| Project | IEEE 802.16 Broadband Wireless Access Working Group < http://ieee802.org/16 > | |
| Title | New Text and Figure to Resolve Comment 706 | |
| Re: | IEEE 802.16 Working Group, Letter Ballot #4, IEEE P802.16a/D1-2001 | |
| Abstract | This document contains a new text and figure to resolve comment 706 to IEEE P802.16a/D1-2001. | |

Figure 227—Creation of OFDMA Randomizer Initialization Vector

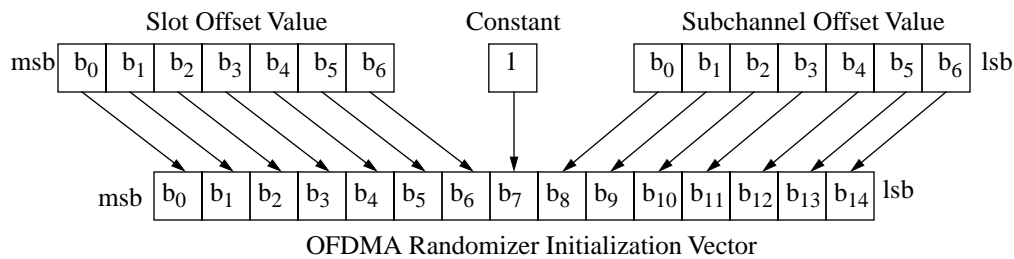
This document contains proposed new text and a figure to resolve comment 706:

This clause defines the 15-bit initialization vector of the scrambler (see clause 8.3.5.3.2.1.1) for both upstream and downstream. Bit 7 is always 1. The other bits are copied from the values of Slot Offset and Subchannel Offset as shown in Figure 227.
